SERVICE BULLETIN

BT02-015

2002 ALTIMA; WIND NOISE DUE TO HOLE IN DOOR SEALER

APPLIED VEHICLE: 2002 Altima

Figure 1

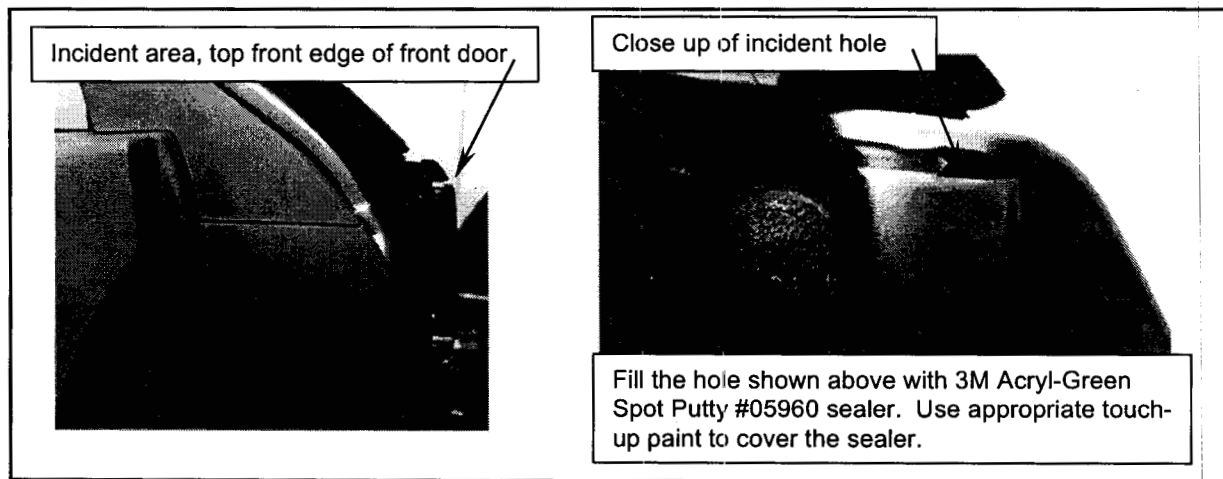
If a 2002 Altima exhibits wind noise (buzzing or whistling sound) around the left or right front door area, particularly in cross-wind conditions, there may be a hole in the door panel sealer at the front edge of the door.

Fill the area shown in figure 1 with 3M Acryl-Green Spot Putty #05960 sealer. Use appropriate touch-up paint to cover the sealer.
